ADDENDUM NO. 7
NEW SOFTBALL COMPLEX FOR TRUSSVILLE CITY SCHOOLS
Architect Job No. 23-72
April 23, 2024
DCM # 20240224

NEW SOFTBALL COMPLEX FOR
TRUSSVILLE CITY SCHOOLS
6344 HUSKY PARKWAY, TRUSSVILLE, AL 35173
TRUSSVILLE CITY BOARD OF EDUCATION

3 IN-GROUND RECEPTACLES
Scale: 1 1/2" = 1'-0"

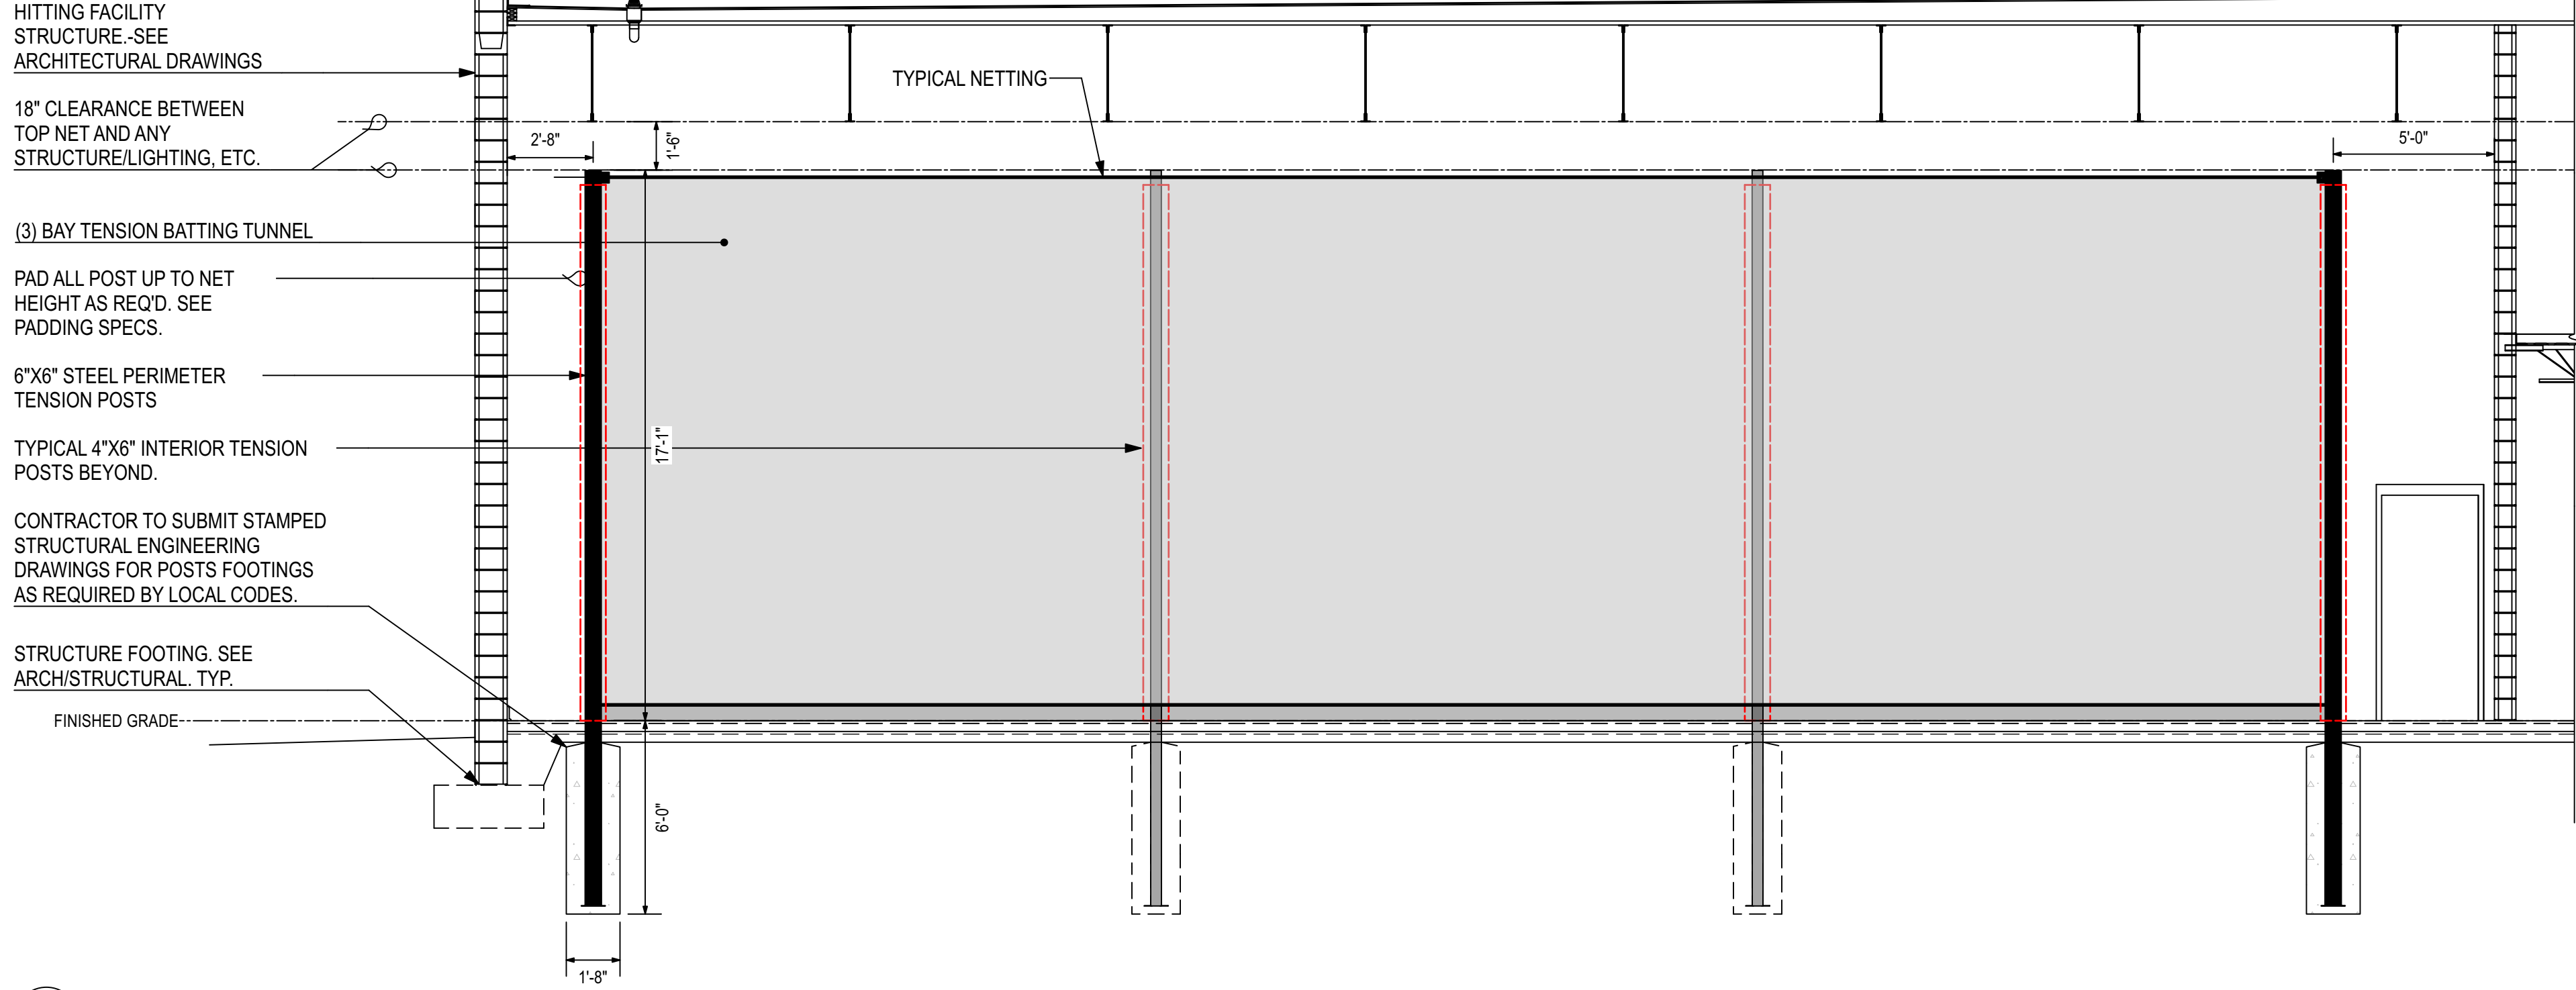
“14. **OUTFIELD DISTANCE MARKERS (VINYL LETTERS, PLASTIC PANEL, ZIP-TIED TO FENCE, LF, CF, RF).**”
3. See attached Sheet **SP6.1** – DETAILS revised Detail 3 “IN-GROUND RECEPTACLES”.
4. See attached Sheet **SP6.2** – DETAILS revised Detail 3 “PLYOWALL MAT-BACK”.
